A585 Windy Harbour to Skippool Improvement Scheme

7.11 Environmental Statement Changes and Corrections Document

Environmental Statement Changes and Corrections Document

Version	Date	Status of Version
Rev 0	May 2019	Deadline 2 Submission
Rev 1	July 2019	Deadline 4 Submission

2m HIGH ENVIRONMENTAL BUND FALSE CUTTING

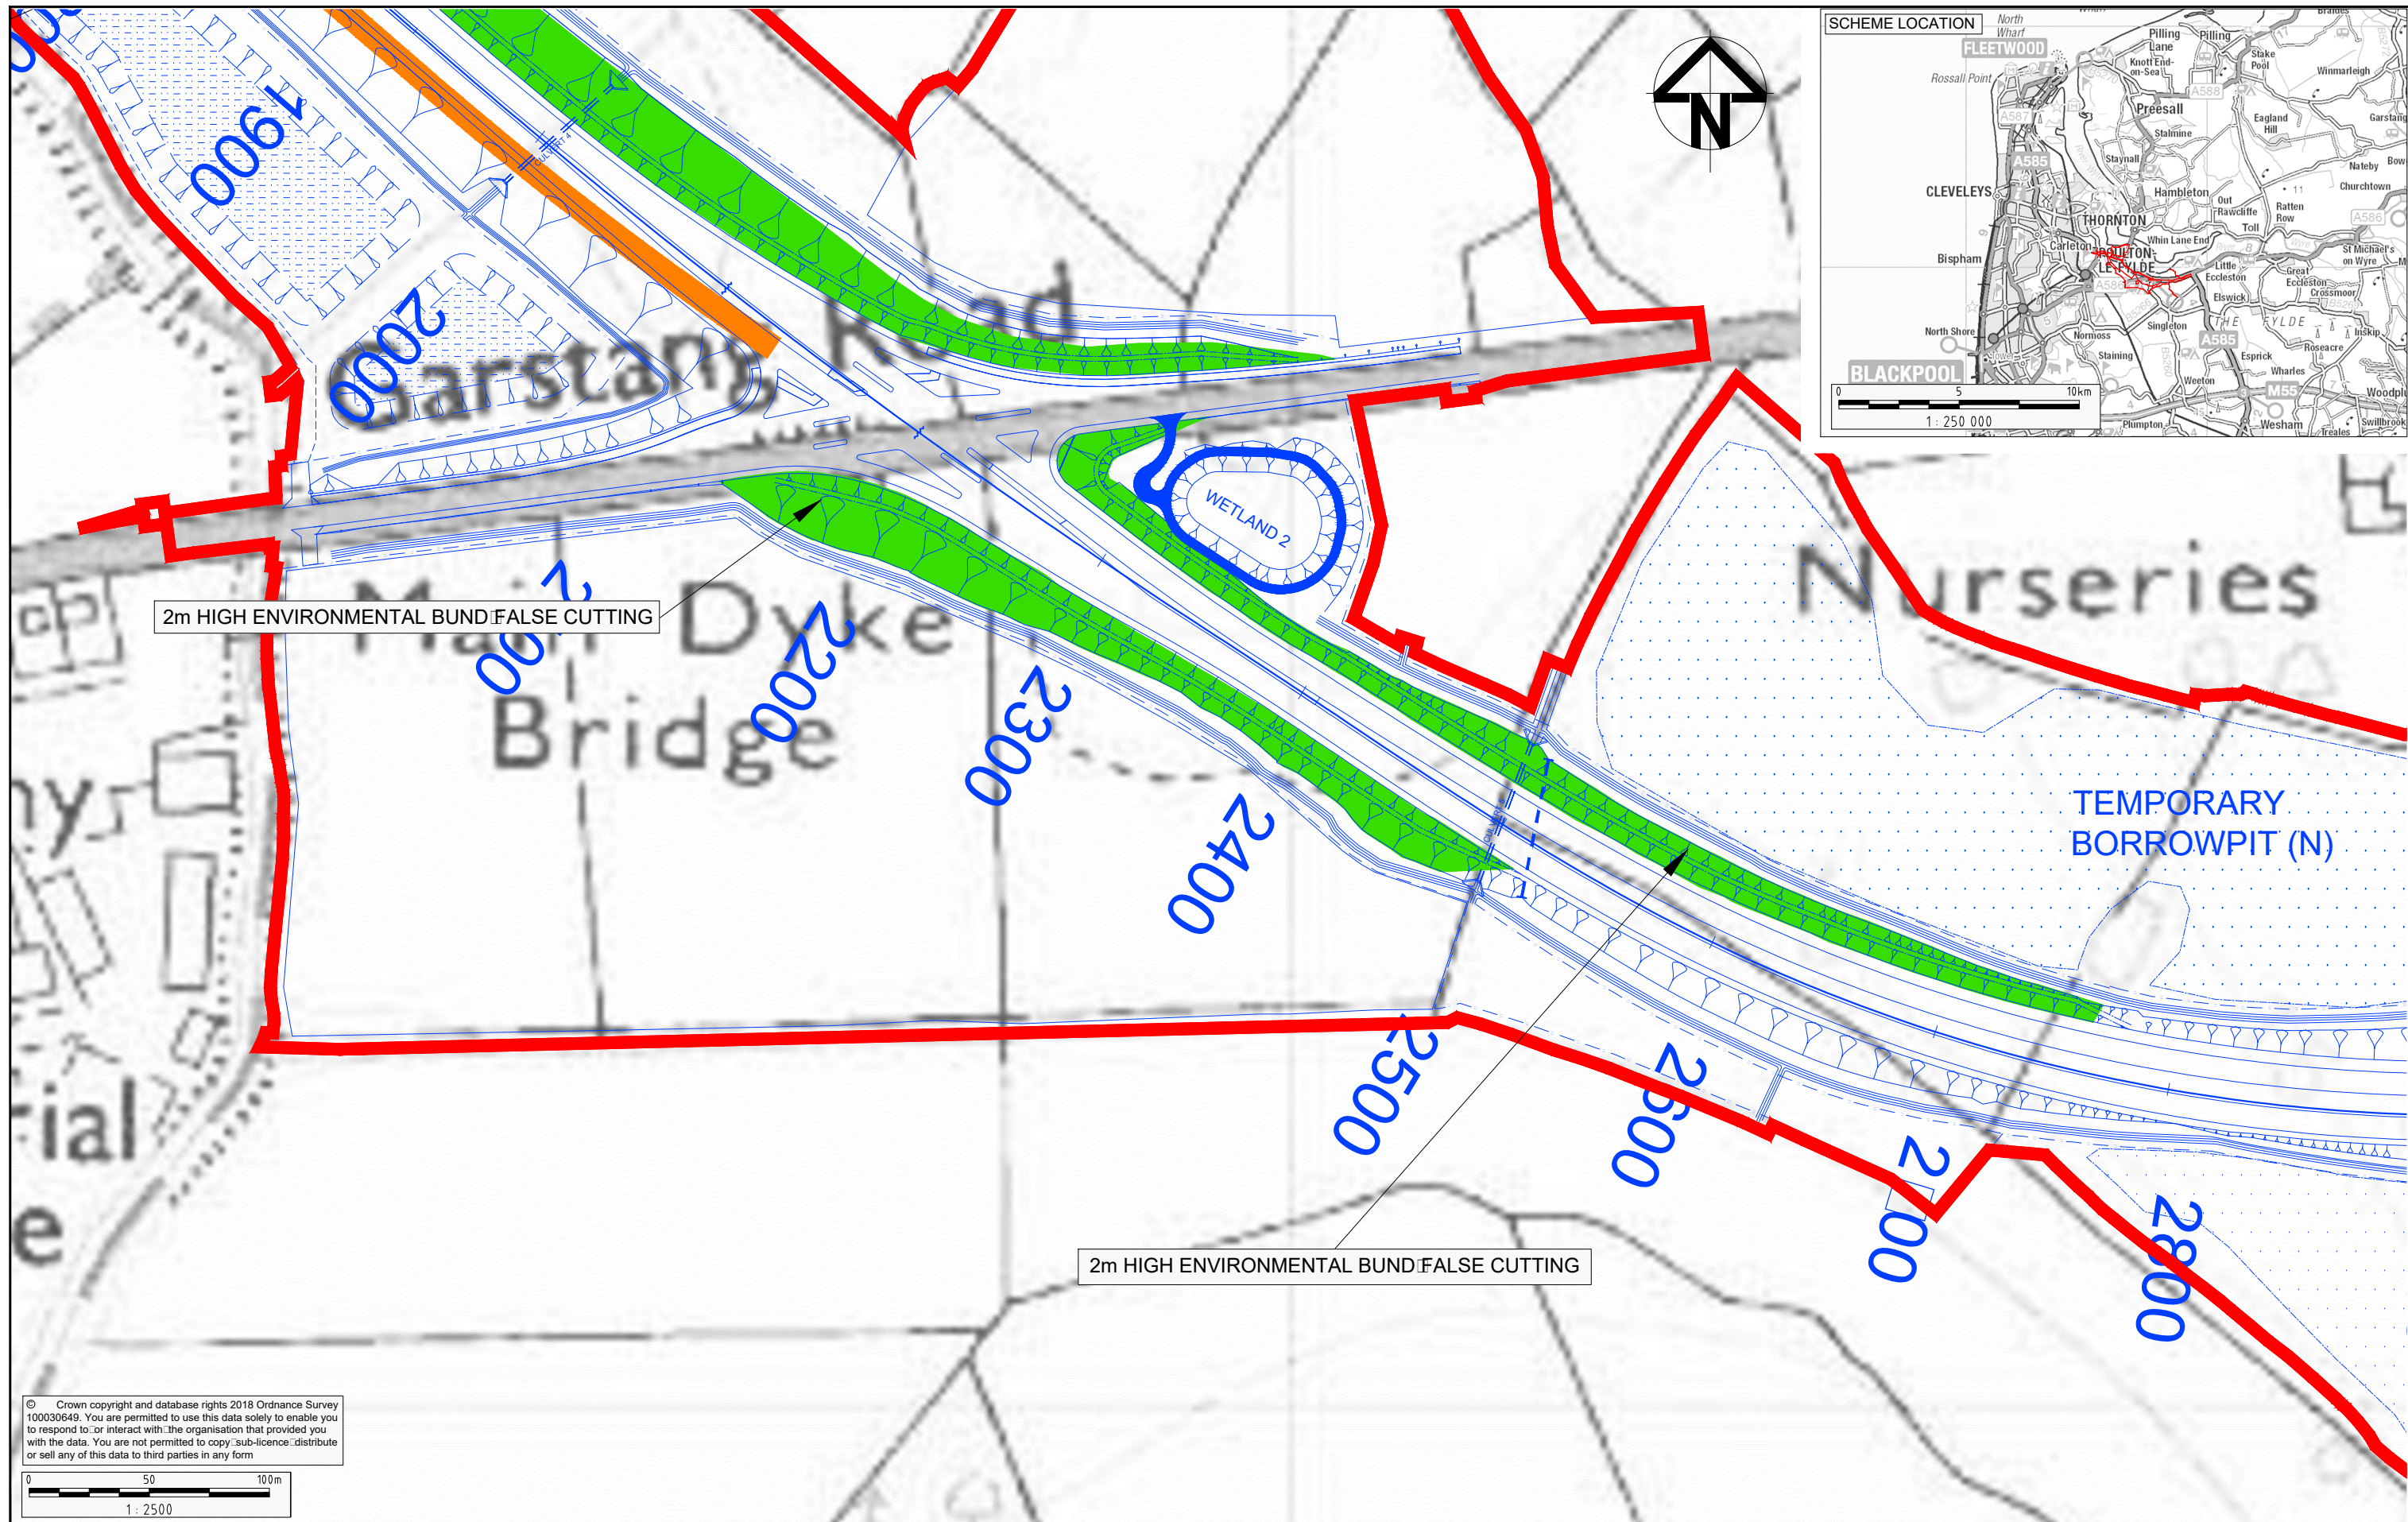
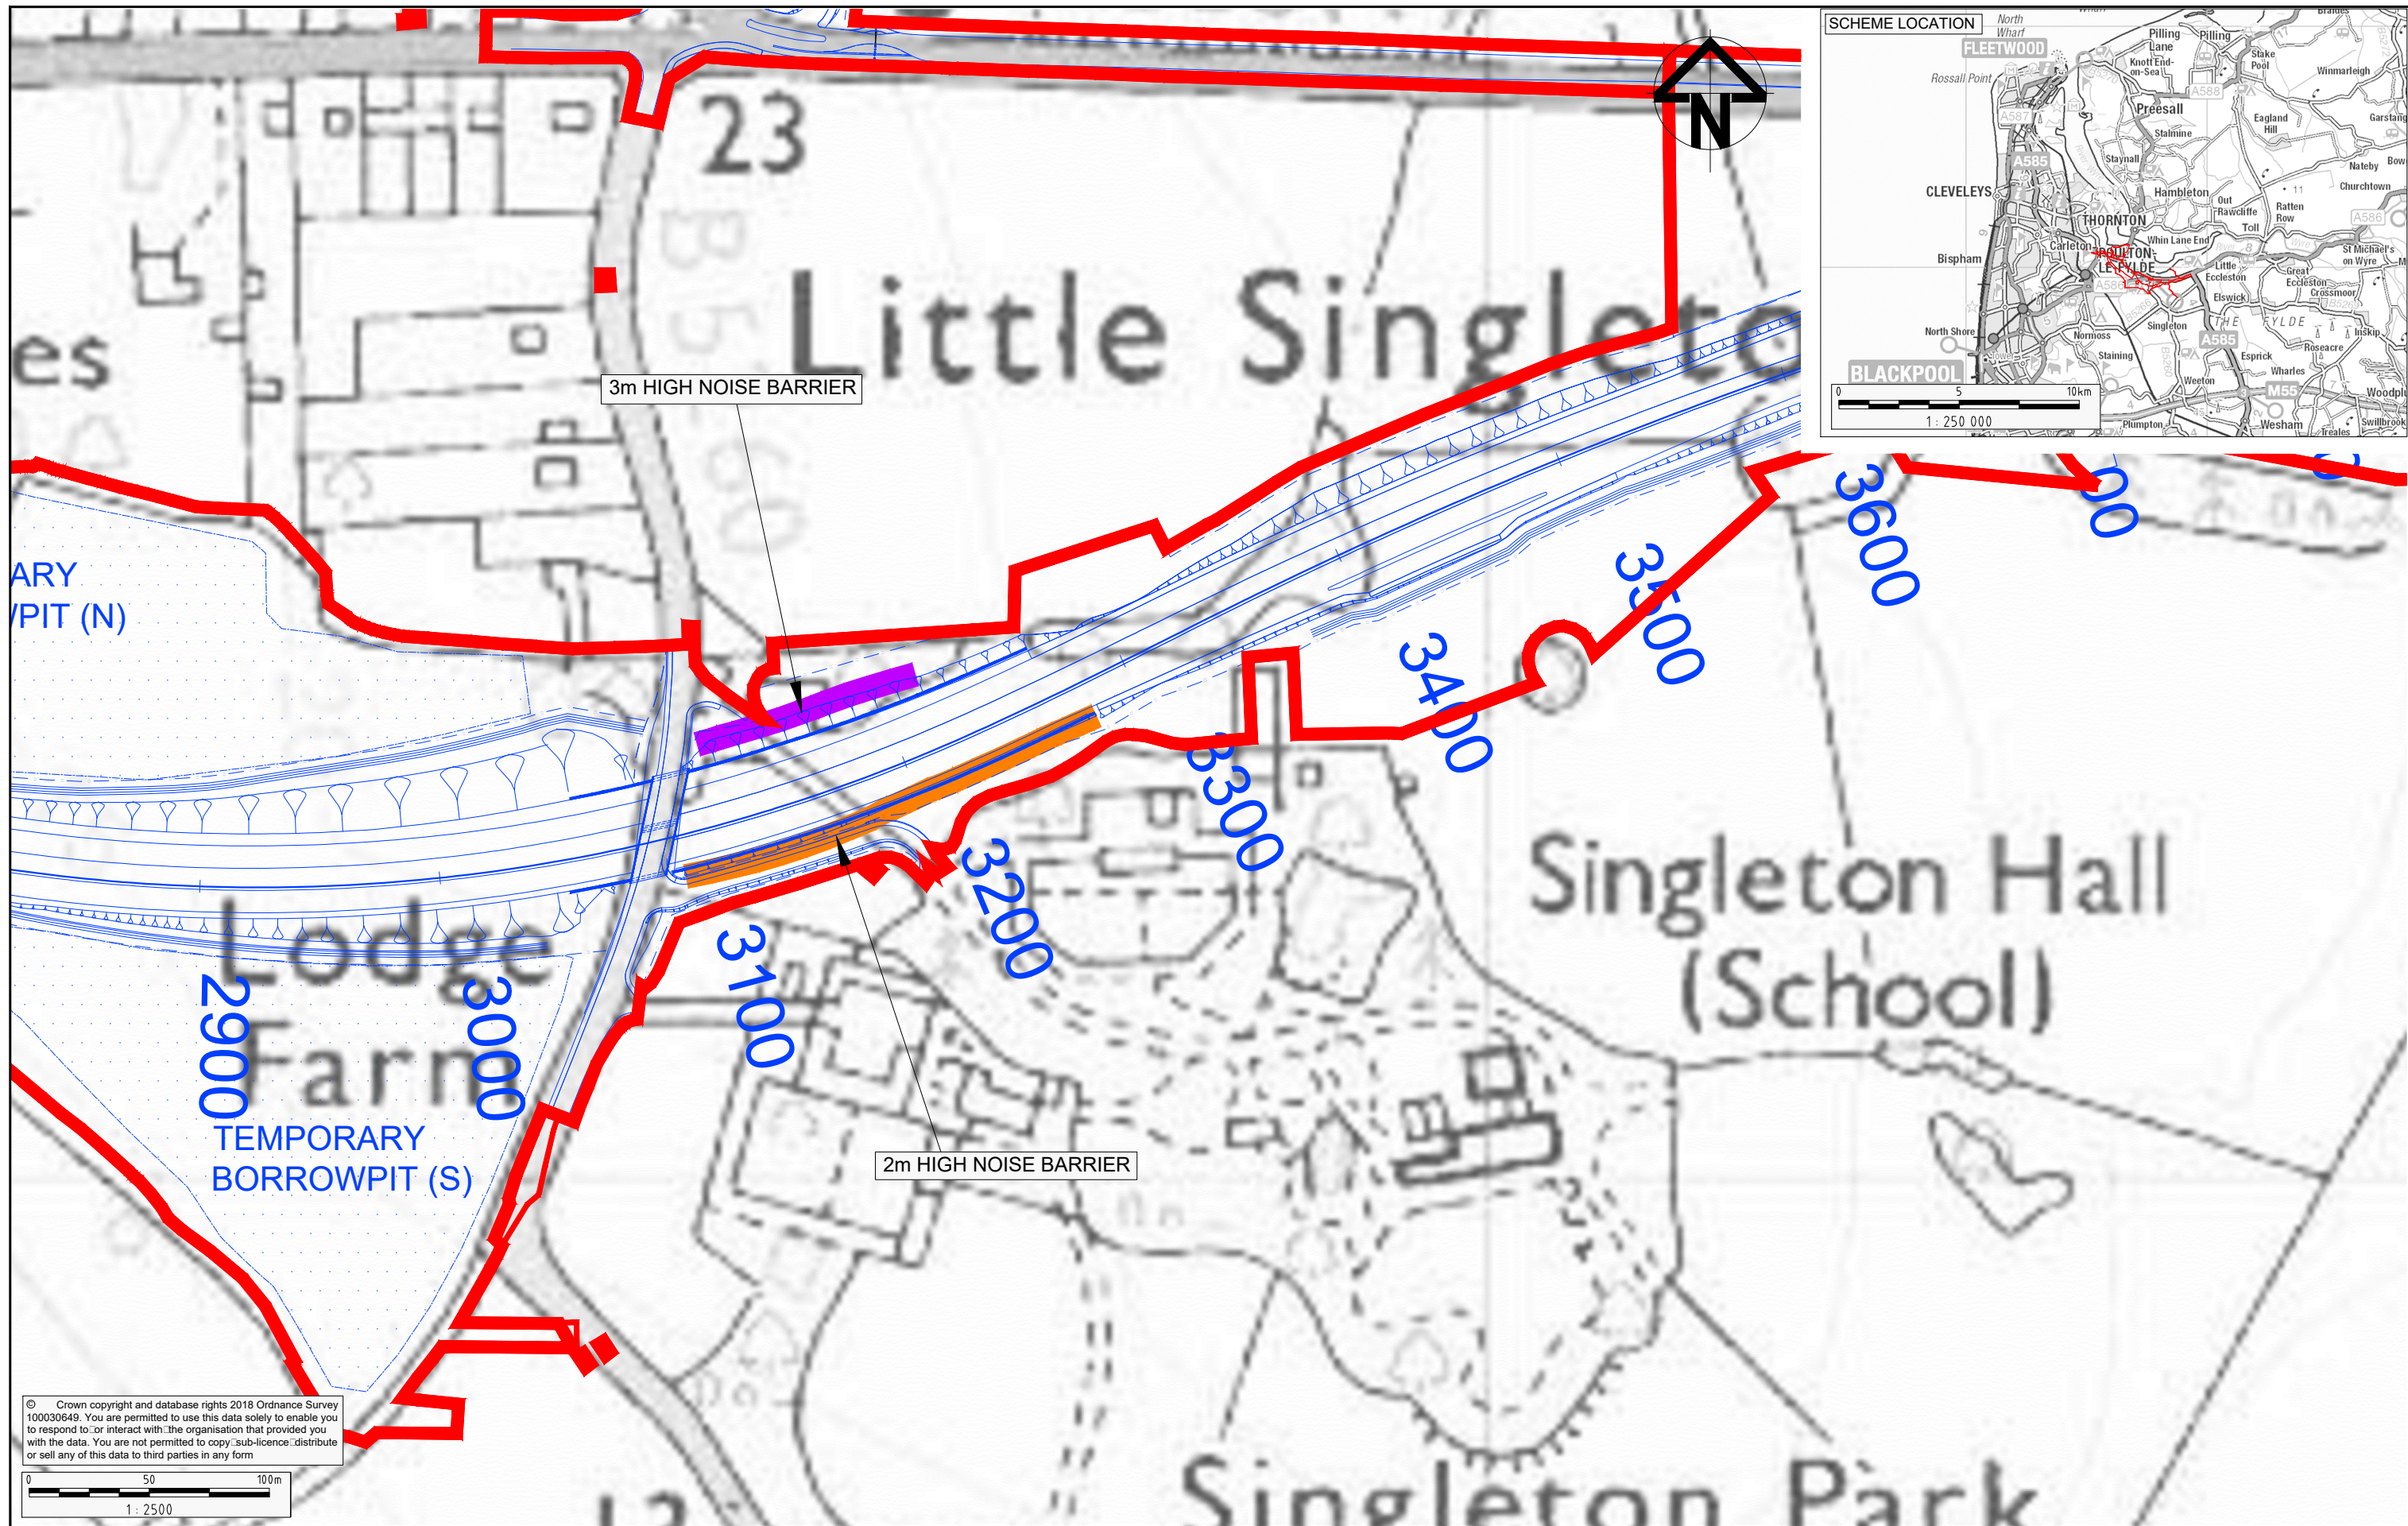
Document Reference Number	Document Name	Amendment Required	Reason
			TR010035/APP/7.10).
6.11	ES Chapter 11: Noise and Vibration	Update to Figure 11.4: Noise and Vibration – Noise Mitigation within the Study Area presented at Appendix D to show heights and locations of earth mounds and acoustic fencing at a larger scale.	Requested by the Inspector within the first round of written questions (document reference TR010035/APP/7.10).

Client
Project A585 WINDY HARBOUR TO SKIPPOOL IMPROVEMENT SCHEME
Drawing Title ENVIRONMENTAL STATEMENT REGULATION 5(2)(a) ROAD DRAINAGE AND WATER ENVIRONMENT: A□IFERS

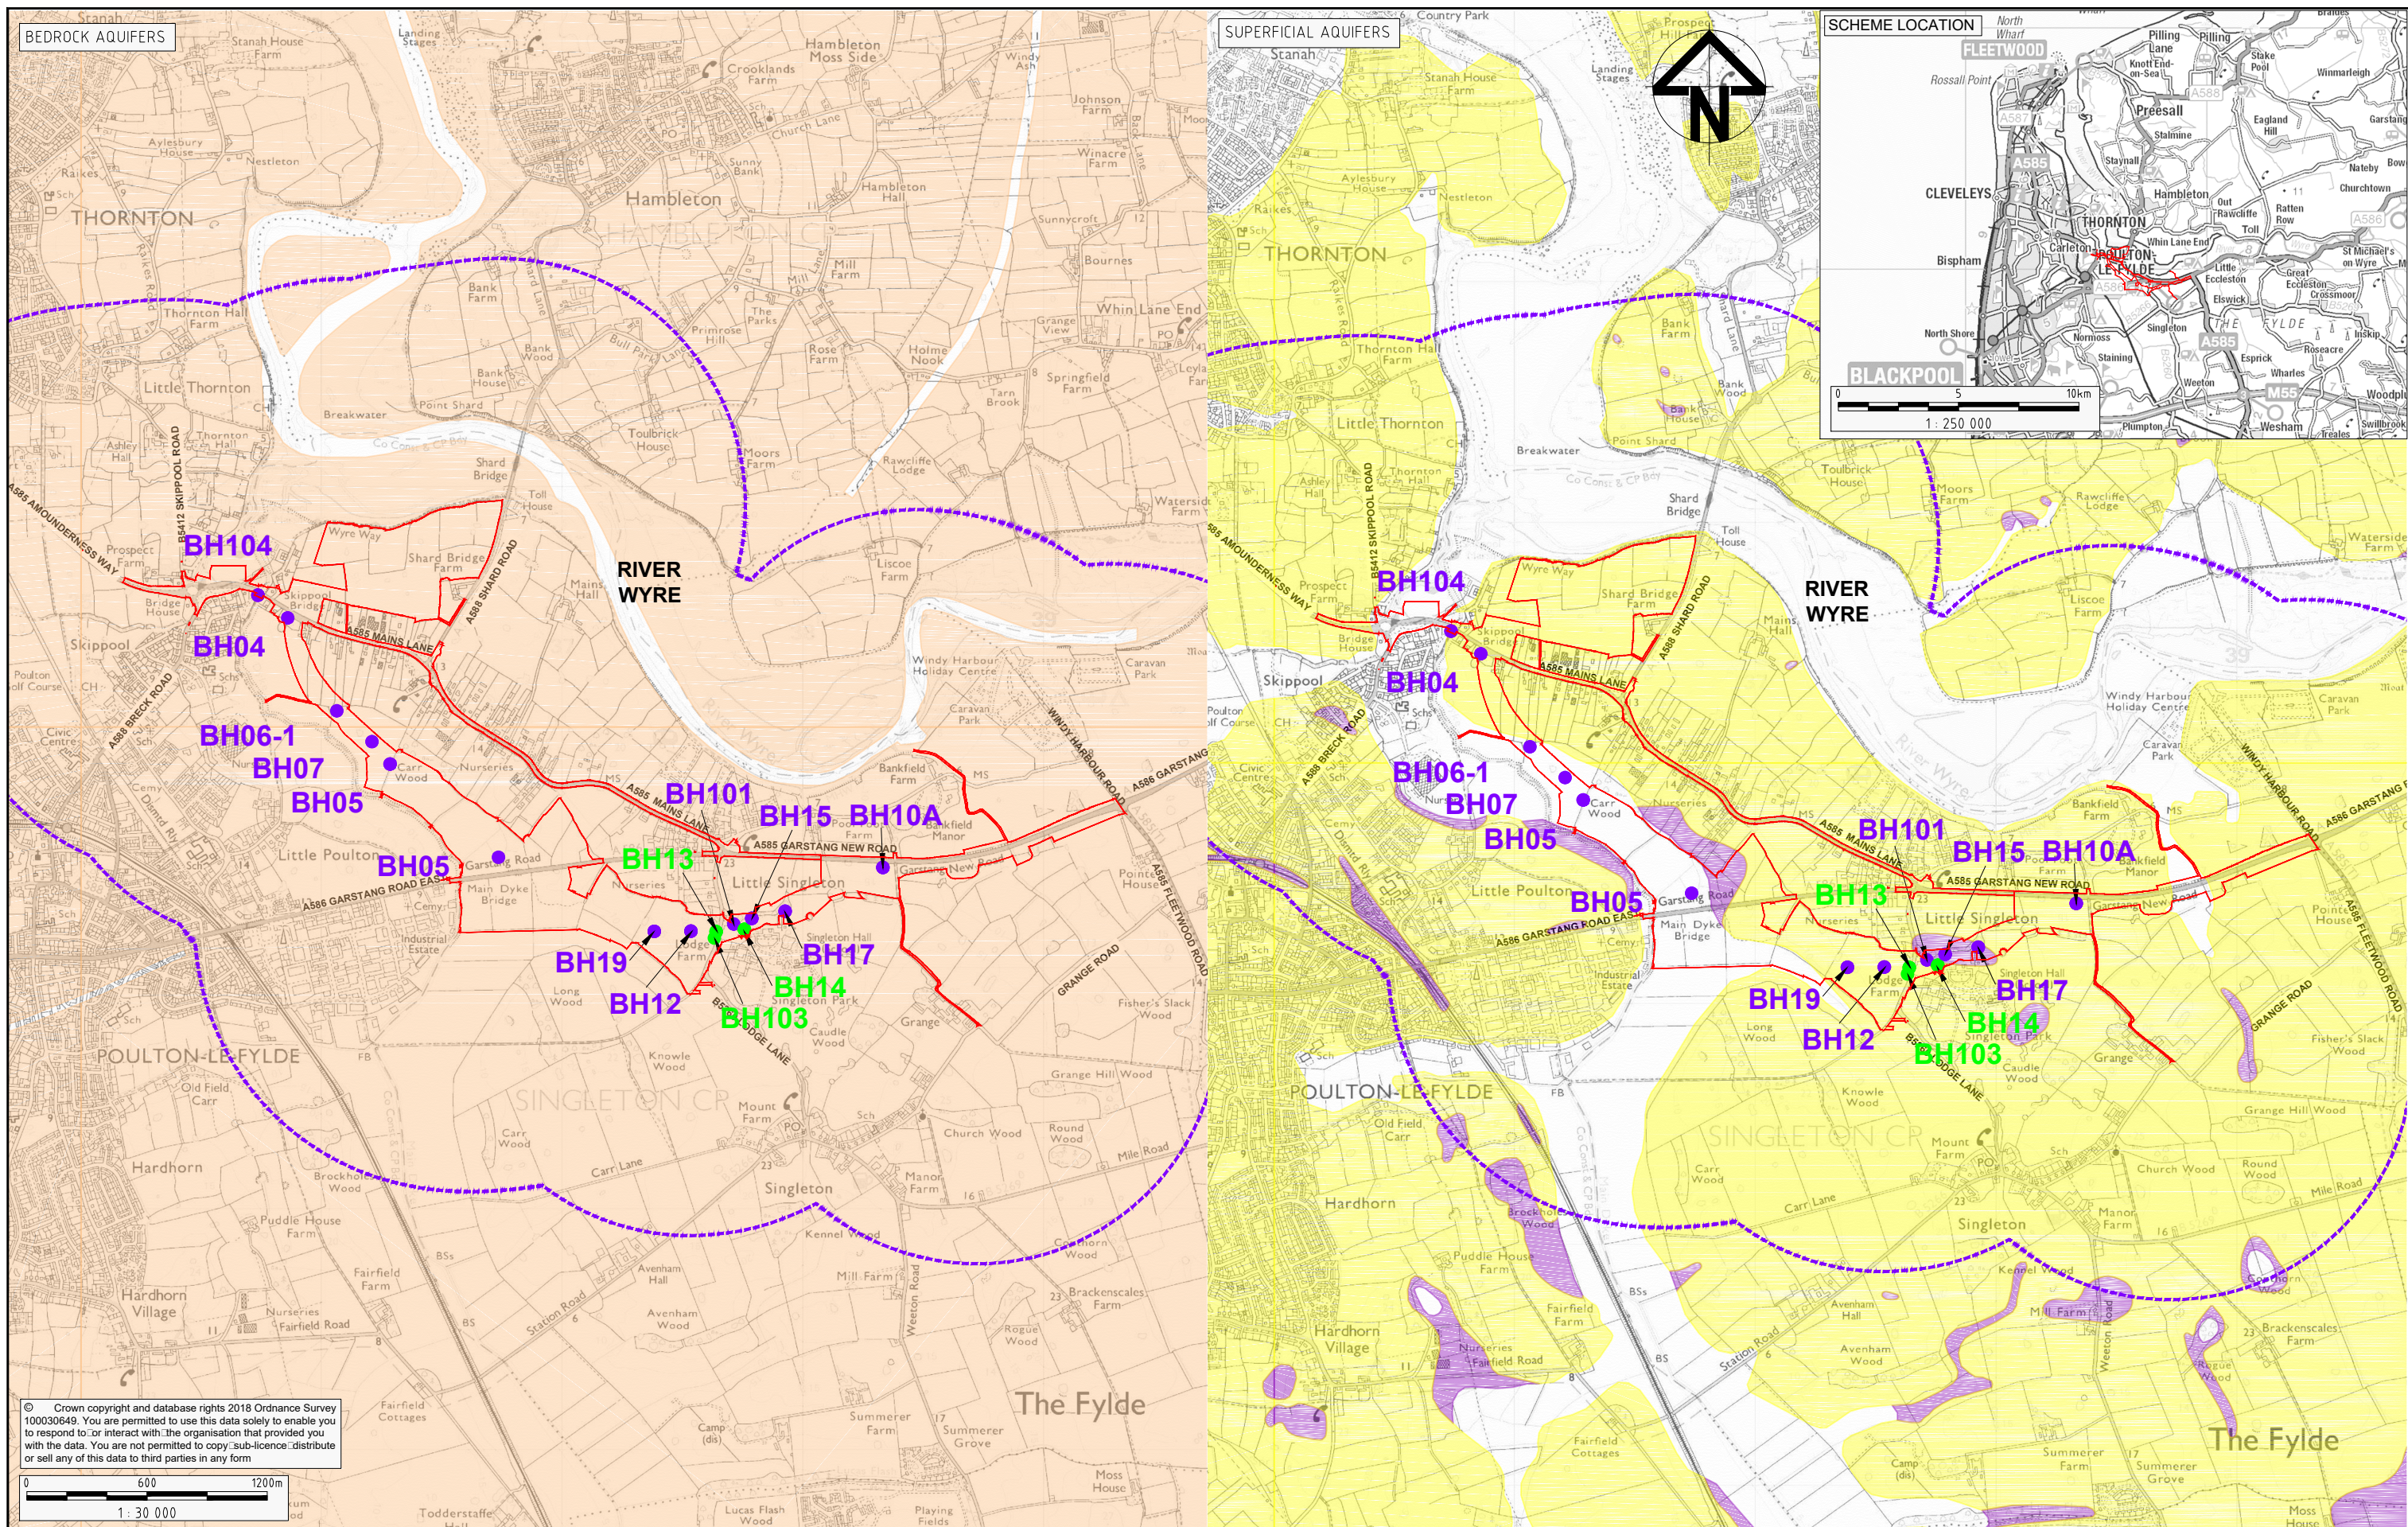
6.12	ES Chapter 12: Road Drainage and the Water Environment	Updated Figure 12.2: Road Drainage and The Water Environment – Aquifers provided at Appendix F to show locations of manual and automated readings for groundwater investigations.	Requested by the Inspector within the first round of written questions (document reference TR010035/APP/7.10).
